Director's Report

Project Name: Edendale

Description: Final Site Plan Approval

RE: Edendale Crossing- Final Site Plan Review – 1st Review

100 YEAR DETENTION BASIN CALCULATION (I.E. WITH OUTLET)

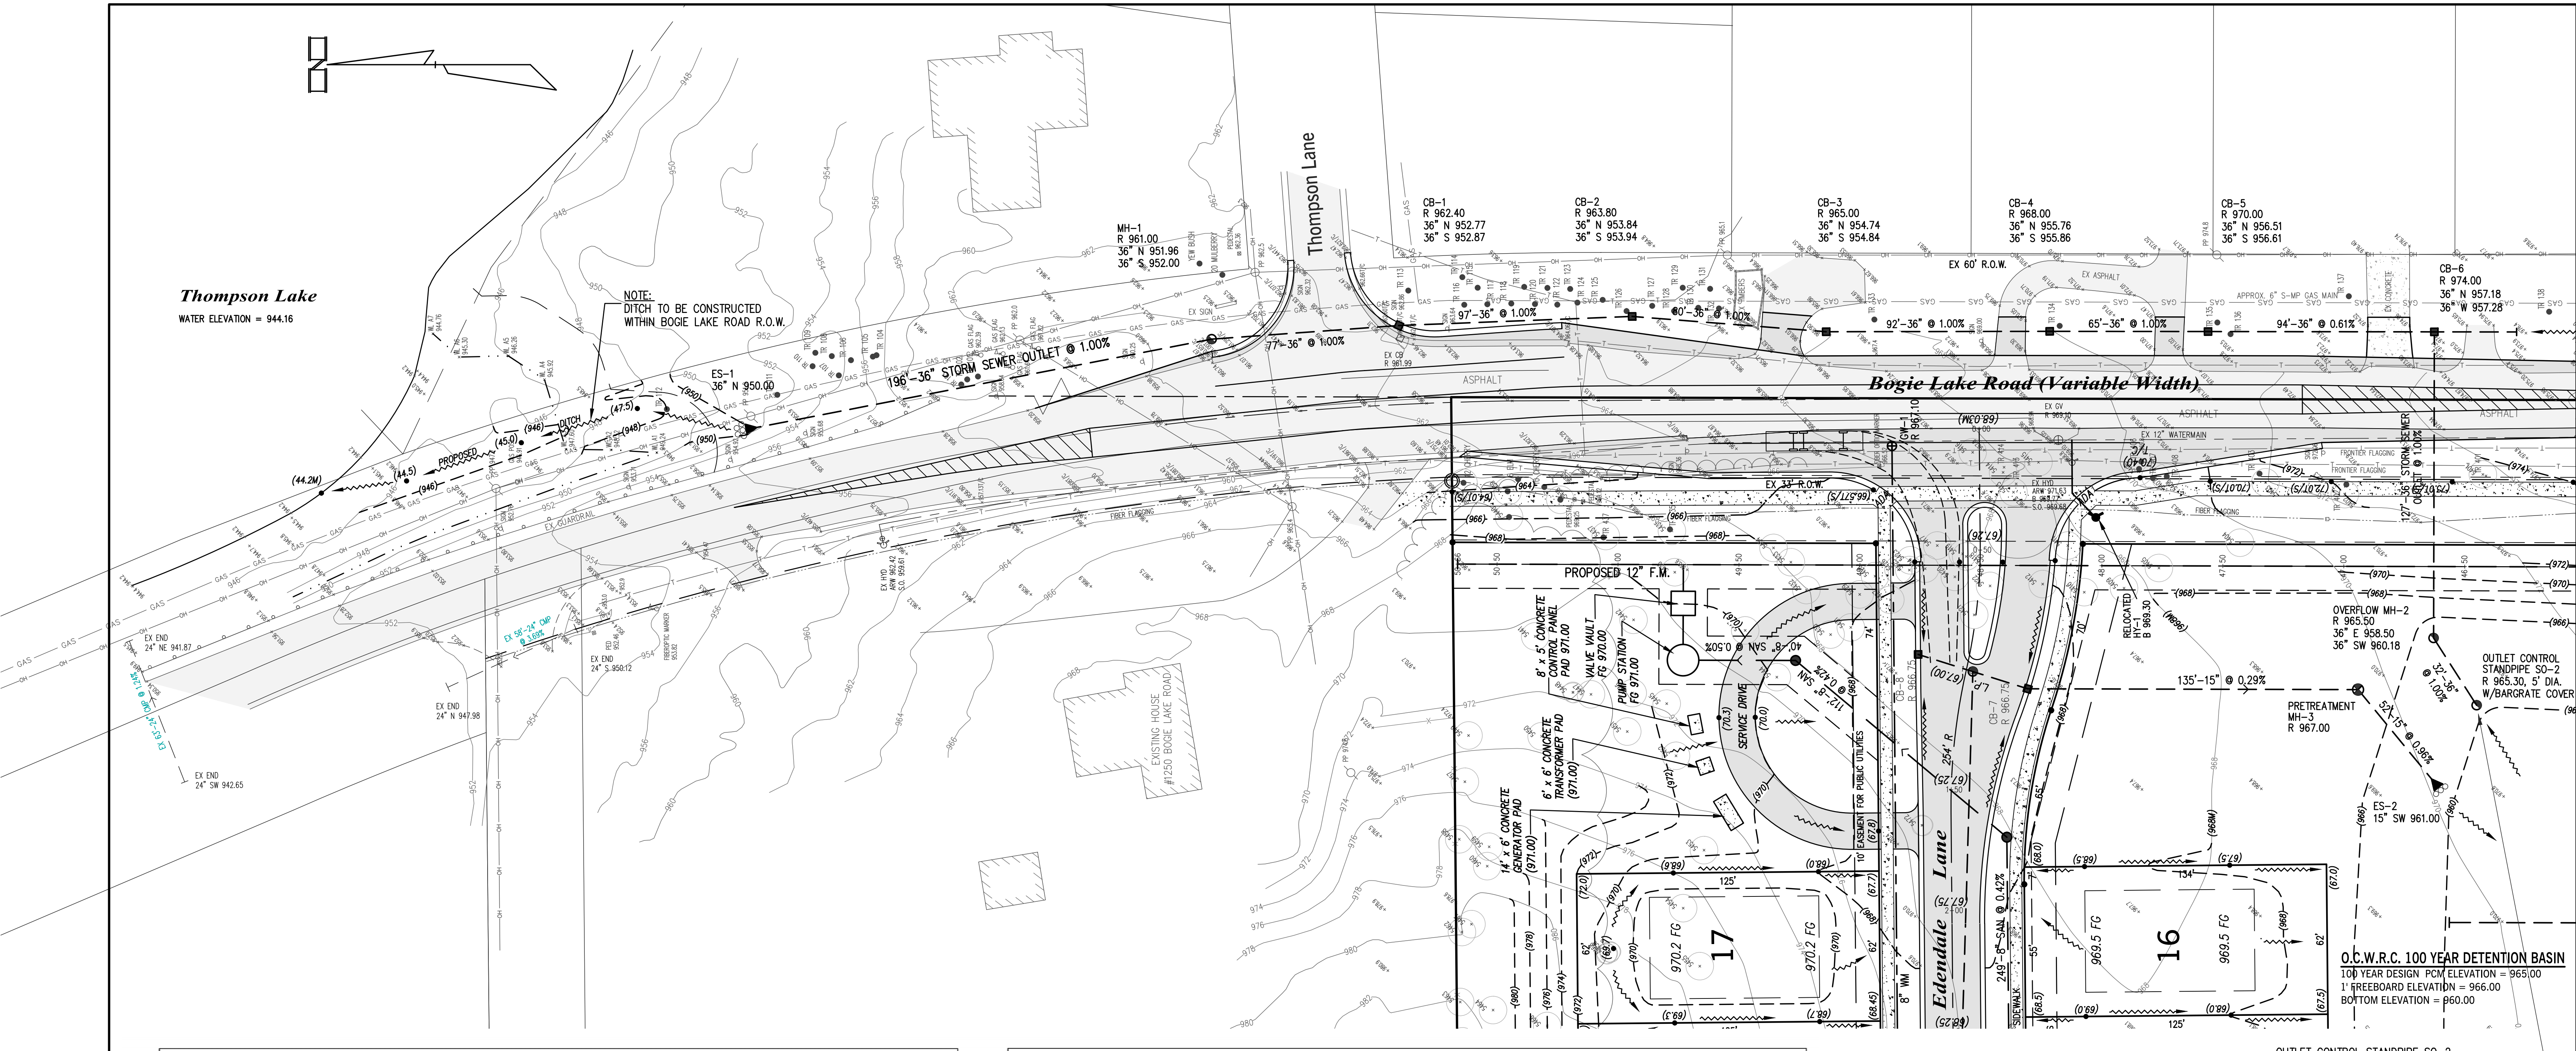
1. Sheet 11- Please see marked up calculations for revisions that shall be required.
2. We note that the location of the proposed sanitary pump station has changed from the Township Board approved Preliminary Site Plan. We consider the revised orientation to be an improvement compared to what was previously indicated so we do not take issue with this item but wanted to note the change.

Shown on Sheet 3 as 3.20 acres

In addition, Sheet reference note on Sheet 3 references Sheet 16; it should be Sheet 11.

Stormwater calculations:	100-year basin calculations have been revised and are provided on Sheet 11

Cedar Island & White Lake Middle School Sidewalk Plan
"EDENDALE CROSSING" SITE CONDOMINIUM
PART OF THE SOUTHEAST 1/4 OF SECTION 29, T3N, R8E
WHITE LAKE TOWNSHIP, OAKLAND COUNTY, MICHIGAN

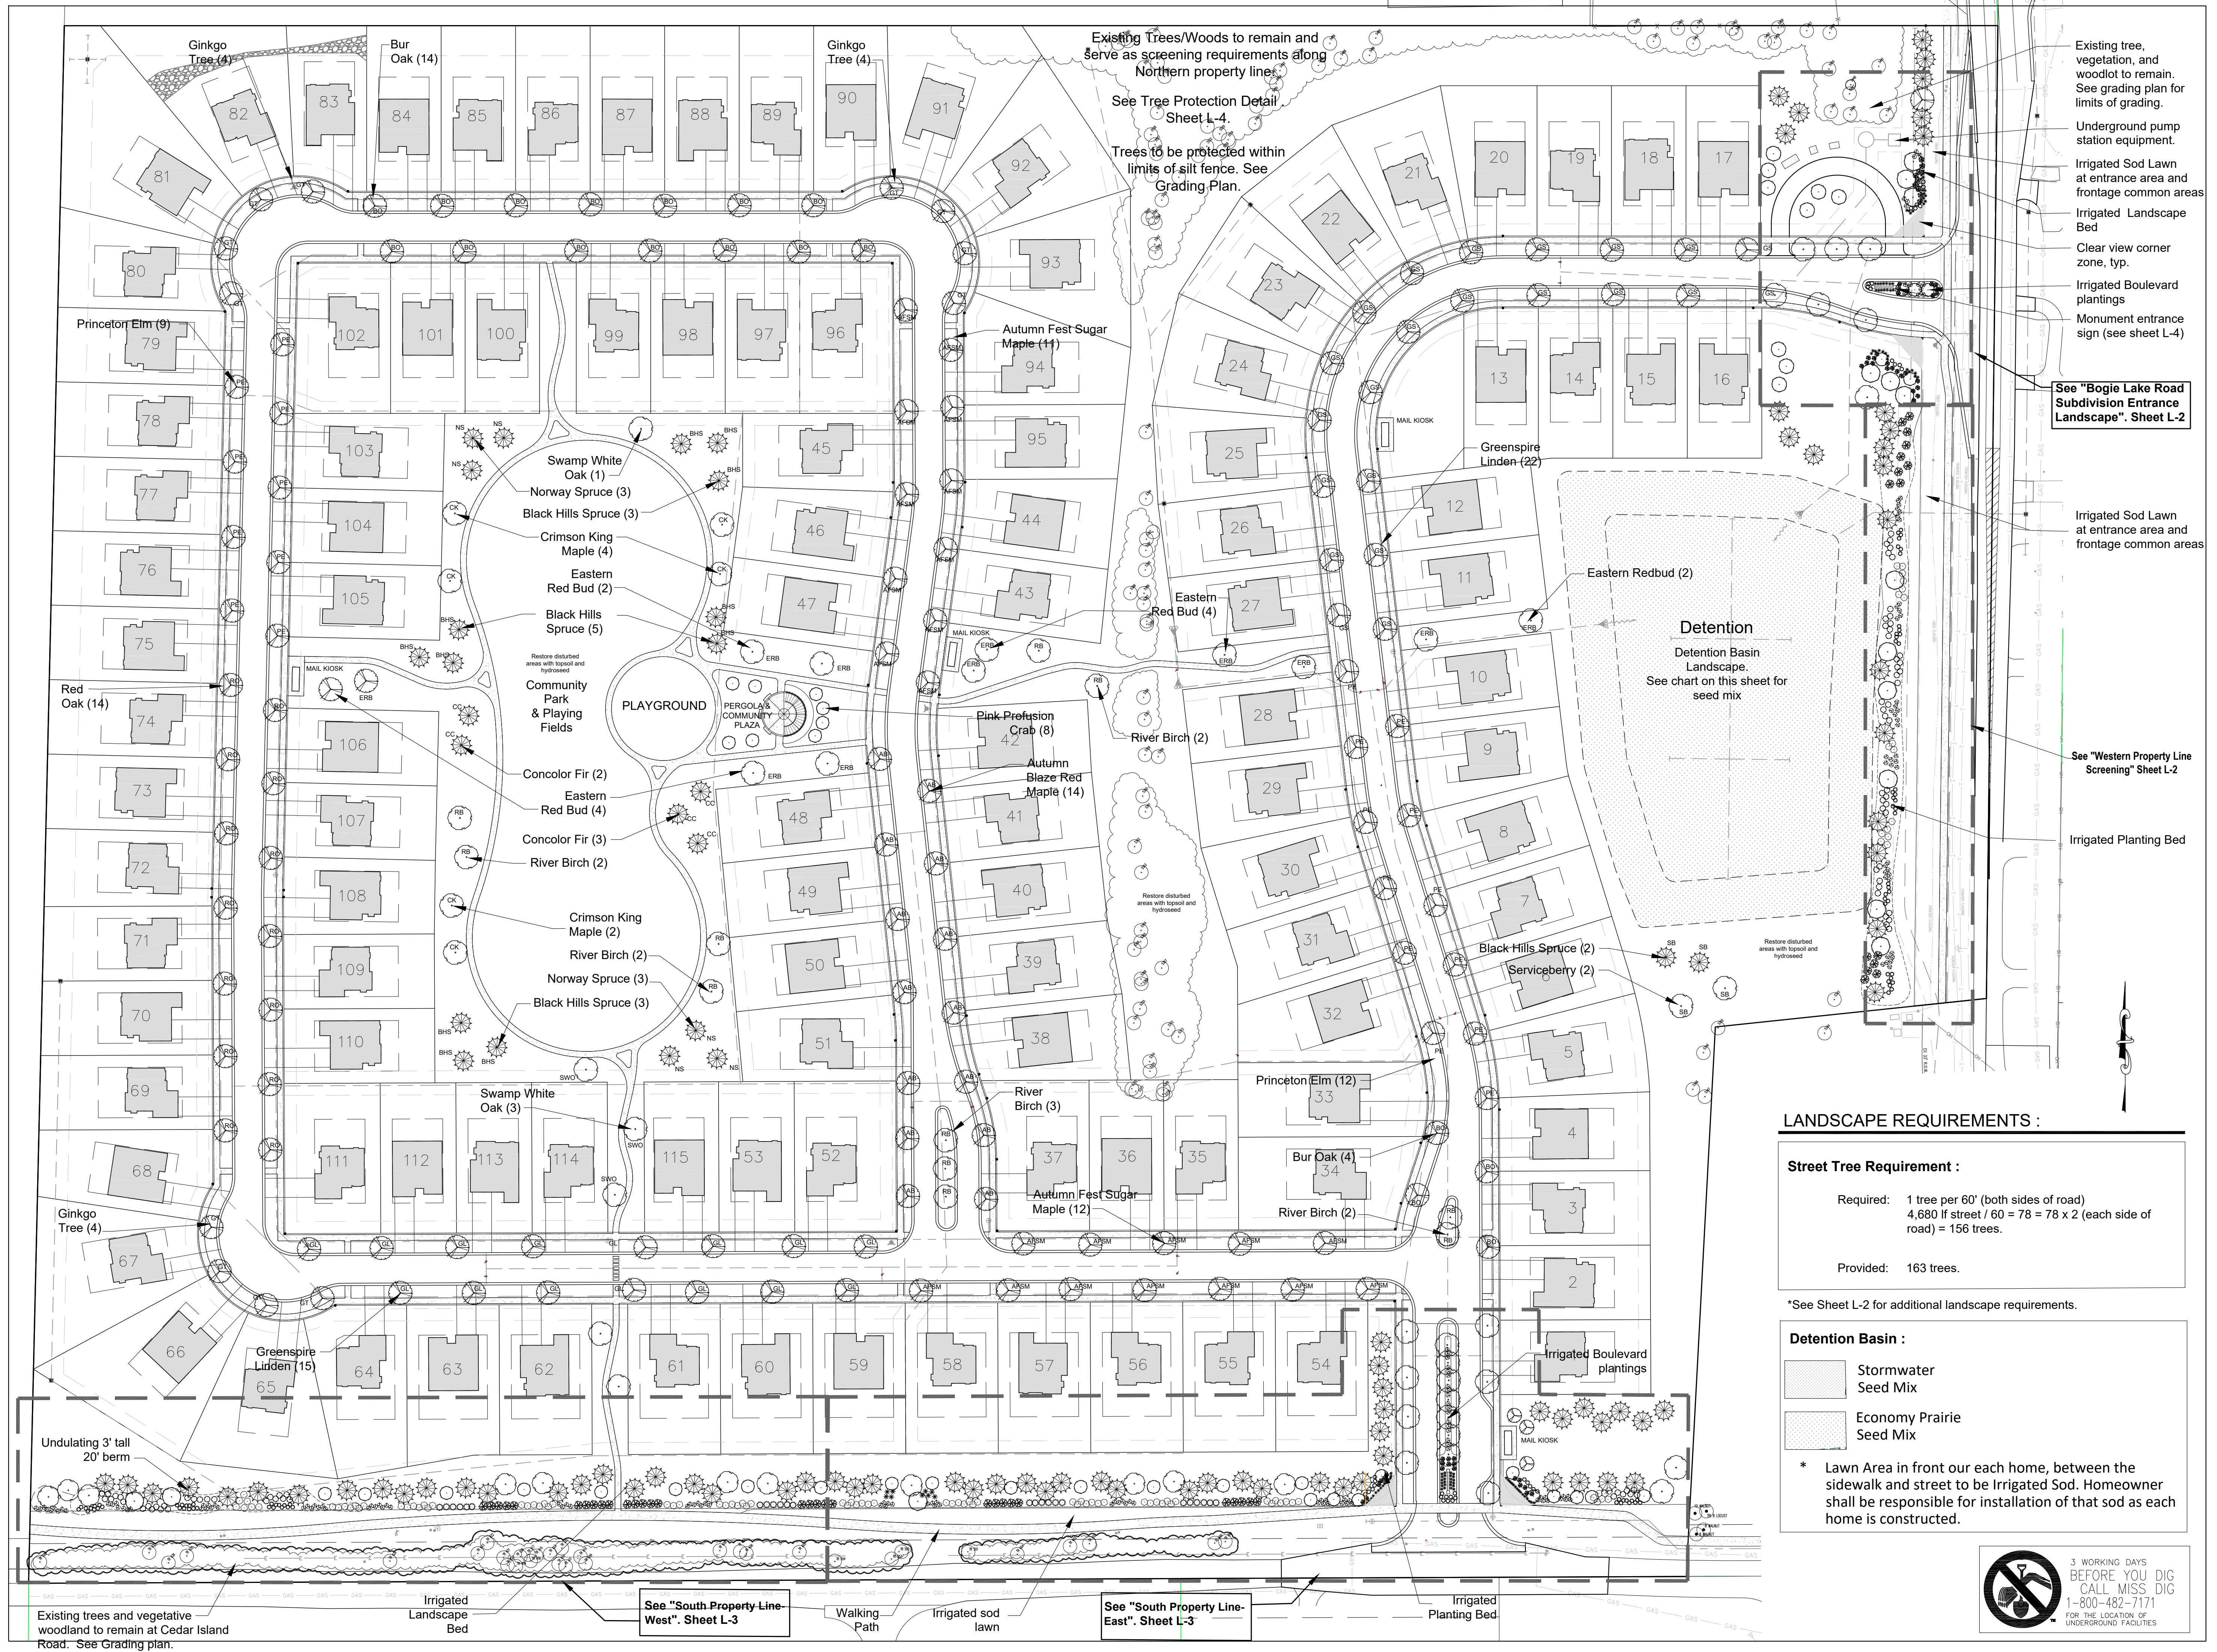
1. *Sheet 19-Cedar Island & White Lake Middle School Sidewalk Plan- Remove 'Proposed Pedestrian School Crossing' note to the west of Carla Hills Drive as this was where the safety path was previously proposed. **Comment outstanding.***
2. *Sheet 3- The number of lots for each phase has not been updated to correspond with the reduction in total units from 125 to 120. Please update. **Comment addressed. Quantities have been updated.***

*Comment is now outstanding due to the following requested clarification and change in sidewalk layout: The proposed 8' wide path along Cedar Island Road has now been shifted in its entirety to the north side of the road. The Existing Conditions Plan- Overall (Sheet 2) shows 43' existing ROW along Cedar Island Road in front of Parcel 12-29-476-007 while the Overall Site Plan and Notes (Sheet 3) shows the existing ROW in this area as 33'. Please clarify. The right of way along Parcel -007 will determine whether a sidewalk easement will need to be granted by this property owner. Additionally, please revise '8' Wide Safety Path Connection to Huron Valley School Parking Lot' reference notes on Sheets 3 and 5 from Sheet 17 to Sheet 19. Comment addressed. ROW width has now been corrected to 43' on the 'Overall Site Plan & Notes' (Sheet 3), so it now appears that an easement for the proposed path would not be required from Parcel -007. In addition, sheet references have been updated. **Comment remains as a notation.***
